MISCELLANEOUS PAPER GL-85-2

REVIEW OF RIGID PAVEMENT DESIGN FOR VEHICULAR PARKING AREAS

1. This paper describes the proposed changes to the design criteria used in TM 5-822-6, "Rigid Pavements for Roads, Streets, Walks, and Open Storage Areas" (Office, Chief of Engineers, Department of the Army 1984). The March 1984 edition of the TM recommends that rigid pavements for roads, streets, and vehicular parking areas be designed using criteria developed for roadways in 1961 (US Army Engineer Division, Ohio River, 1961). Since then, experience with test sections and in-service pavements has added to knowledge of pavement mechanics. The old criteria appear conservative, especially for vehicular parking areas, which are loaded differently from roadways.

Figure 1. Rigid pavement design curves for roads and streets

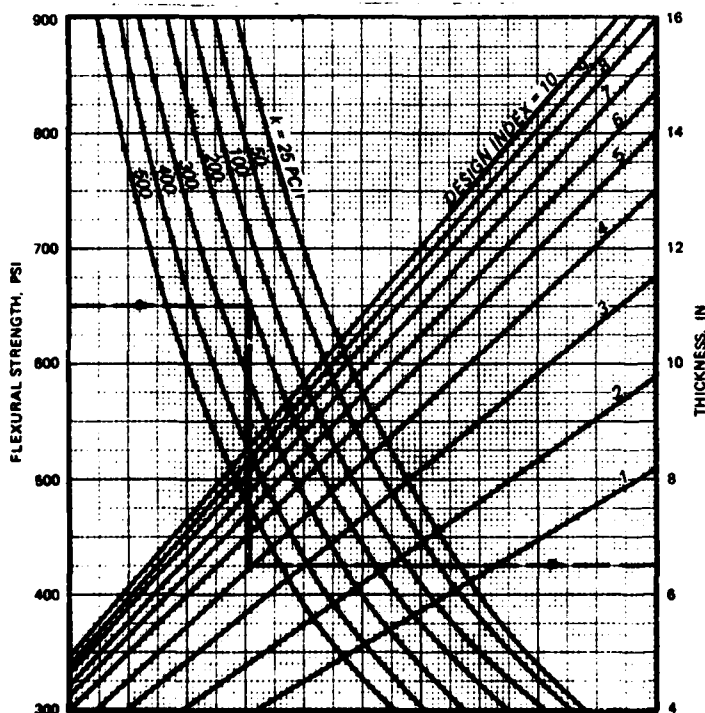
5. Tests have shown that test vehicles on pavements experience impact effects. However, the pavements themselves do not. The axle loads of a moving truck cause smaller stresses than those of a stopped truck. In the Maryland Road Test (Highway Research Board 1952), stresses were measured at pavement edges and tranverse joints for speeds up to 40 mph.* Stresses at outside edges decreased 30 percent when truck speeds were raised from creep to 40 mph. Stresses at transverse joint edges decreased 15 percent at 40 mph. Stresses were decreased still more when 3/4-in. boards were placed on the pavement to simulate joint faulting. Similar results were reported from the American Association of State Highway Officials (AASHO) Road Test (Highway Research Board 1962). This agrees with USACE experience and with the current philosophy for design of airfield pavements. Therefore, use of an impact factor is not justified.

6. Previously, the standard thickness (for 5,000 coverages) was calculated using a combined design factor of 1.55. This included a 25 percent increase in the static load for impact and a 30 percent increase for load repetition. Eliminating the impact factor reduces the combined design factor to 1.3, for a thickness reduction of about 11 percent.

8. The change in thickness of roads, streets, and vehicular parking areas resulting from this modification depends upon the design traffic coverage level. For low coverage levels, the design thickness is reduced as much as 4 percent. For high coverage levels, the thickness is increased as much as 19 percent.

9. Current airfield pavement design includes a thickness reduction for high-strength subgrades. This reduction is based on USACE experience, and its validity is illustrated by the performance of concrete block pavements on high-strength subgrades. This same reduction (Hutchinson 1966) has been applied for roads, streets, and vehicular parking areas. The amount of thickness reduction depends upon the value of the modulus of soil reaction, k . For k values above 100 pci, the reduction in design thickness varies from zero (at $k = 200$ pci) to a maximum of 19.1 percent (at $k = 500$ pci).

10. The cumulative change in design thicknesses of roads and streets depends upon the coverage level (design index) and subgrade strength. It varies from an increase of 9 percent to a decrease of 19 percent for typical values of design parameters. The new rigid pavement design curves for roads and streets are shown in Figure 1.

Figure 2. Rigid pavement design curves for parking areas

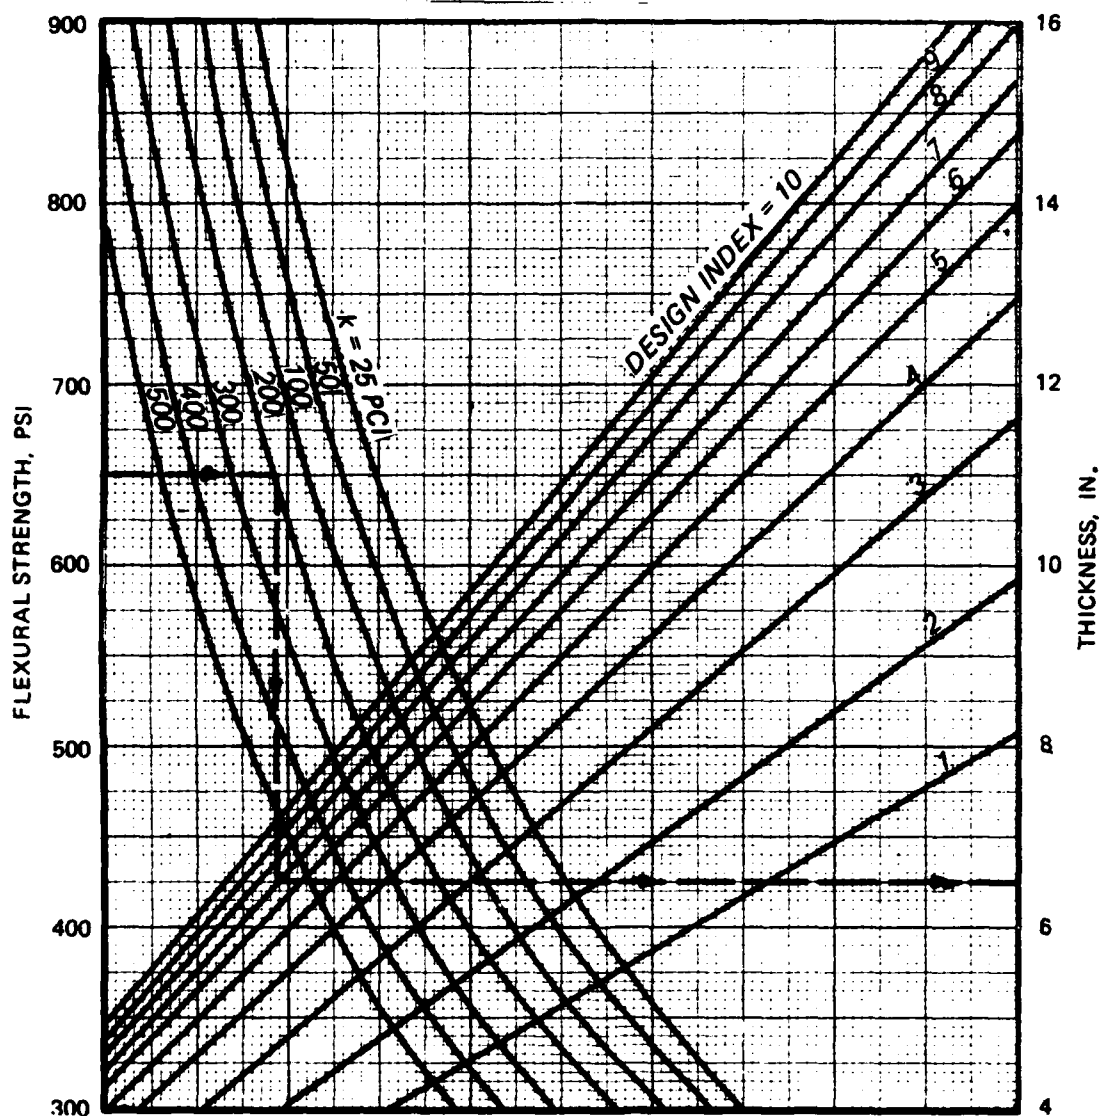
11. A survey of parking areas and traffic patterns on various military installations was conducted by the project engineer. One observation from this survey is that traffic avoids the free edges of parking lot pavements. This phenomenon is caused by curbs, fences, buildings, soft ground, etc., common along the edges of parking areas. Since the free edges are not heavily trafficked, the maximum damage to parking lot pavements results from stresses caused by traffic loads along interior joints rather than along free edges. These interior joints are load transfer joints. A 25 percent load transfer is used for interior joints of airfield pavements (Parker et al. 1979). Therefore, the maximum design stresses in parking lot pavements can be estimated at 75 percent of the free edge stresses. Using these reduced stresses allows a design thickness reduction of about 17 percent.

13. The cumulative decrease in parking area design thickness, depending upon coverage level and subgrade strength, is 12 to 27 percent for typical values of design parameters. The new rigid pavement design curves for vehicular parking areas are shown in Figure 2.
